NOTICE OF VIOLATION

INSPECTION REPORT

Electrical Corporation:	PacifiCorp				
Report Number:	PC_GCA_20240604_1315				
Inspector:	Gary Candelas				
WMP Year Inspected:	2024				
Data Request Referenced:	DR-229, April 1 to May 8, 2024 vegetation management data				
Inspection Selection:	Energy Safety inspected the locations based on PacifiCorp's response to DR-229				
Relevant WMP Initiative(s):	8.2.3.1.2 - Pole Clearing				
Date of inspection:	June 4, 2024				
City and/or County of Inspection:	Mount Shasta, California				
Inspection Purpose:	Assess the accuracy of PacifiCorp's QDR data, completeness of its work, compliance with WMP requirements,				
	and compliance with its protocols.

Item1IA1Img1: Dead branches are within the 10-foot radius of the pole and approximately 10 feet from the ground.

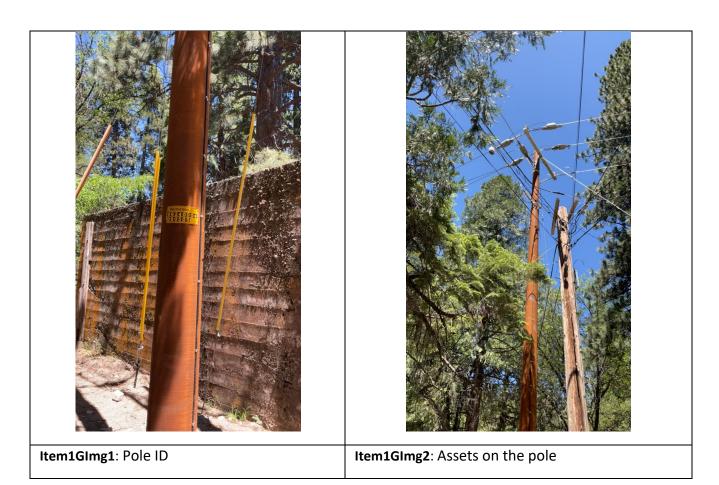
The reported location provided by PacifiCorp indicated that work per WMP initiative number 8.2.3.1.2- Pole Clearing was completed. The pole (ID 90505) is located in Mount Shasta City Park, near the intersection of Nixon Road and North Mount Shasta Boulevard and at GPS coordinates 41.3271629996257, - 122.323769769563. The inspector observed a white fir tree with dead branches within the 10-foot radius of the pole and approximately 10 feet from ground. The inspector's observation is documented in Violation 1 photographs, which are attachments to this report. Photo numbers Item1IA1Img1, Item1IA1Img2, Item1IA1Img3, Item1IA1Img4 depict dead branches approximately 10 feet from ground.

Energy Safety concludes that Violation 1 is "Minor" because the branches within the 10-foot radius are not near the conductors.

Item1IA1Img2: Dead branches are within the 10-foot radius of the pole and approximately 10 feet from the ground.
